DATE	24/08/2021	JOB	2808	PAGES	1 of 10
PROJECT	Trinity Grammar School The Renewal Project SSD				
TO	Peter Brogan				
COMPANY	Bloompark Pact				
FROM	PMDL				
REFERENCE	Response to IPC letter dated 16 August 2021.

In response to the relevant items raised in the letter from the IPC noted above, we advise as follows:

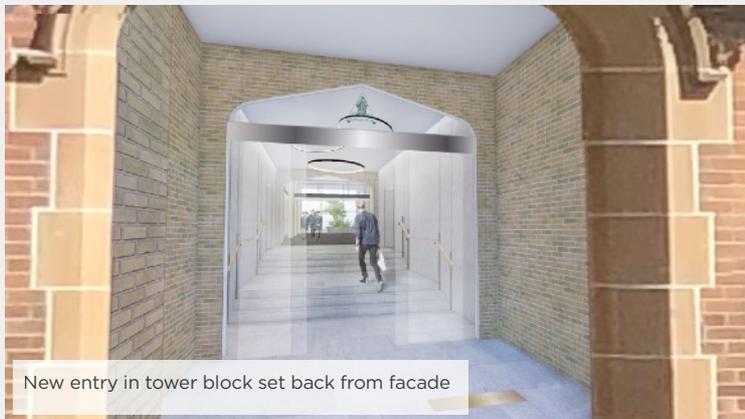
Response: Please find accompanying this memo set of 1:20 wall sections as requested by the IPC, demonstrating typical cladding, window and floor details to T&L building. Drawing list 2808 DA400 Detail 1 A 2808 DA401 Detail 2 A
5	<b>Details of the interface between the new and proposed infill buildings with the existing buildings. Particular focus is required to enable an understanding of the design approach to the interface between the Quadrangle Building and the new Teaching and Learning Building and also between the New Performing Arts Building, the Assembly Hall and the existing music building.</b>

New Teaching and Learning Building and Quad Building

Intervention to the Quadrangle building is proposed through the Tower block to create a new entry to the Library in the new T&L building. This will provide a key connection between the Quadrangle court and the new development. The Quadrangle building will be re-fitted to contain spaces to support the Library functions, and house a number of administration offices and staff rooms as part of the re-furbishment works.

Existing fabric of the Quad building is to be retained at the interface with the new T&L development. The glazed facade and skylight proposed at the junctions along the interface of new and old buildings will be carefully detailed in design development. The intent of using glazing to the junctions is to touch lightly the existing building, as well as maximising opportunity to bring in natural light to an otherwise deep floor plate. See Building Section DA and Wall section drawing DA401 demonstrating design intent.

New Performing Arts Building with the Assembly Hall and the existing music building

The New performing arts building infill will contain a number of functions such as the black box theatre, new assembly hall lobby and T&L spaces. The infill building will connect to the existing Music building to the south, and Assembly Hall to the west.

To the music building, the southern lift and egress stairs block will sit against the existing building. Refer to section DA330. The new masonry facade will provide the necessary separation, both as a fire strategy and an architectural treatment against the existing building. It will also assist in the mean to shroud any inconsistencies in the existing facade.

To the east of the infill building, the new development will create internalised spaces such as the assembly hall lobby and teaching and learning spaces against the Assembly building. From the south east elevation, the new addition will be a framed protruding glazed box, with vantage out to oval 1. Please see updated elevation drawing DA321.
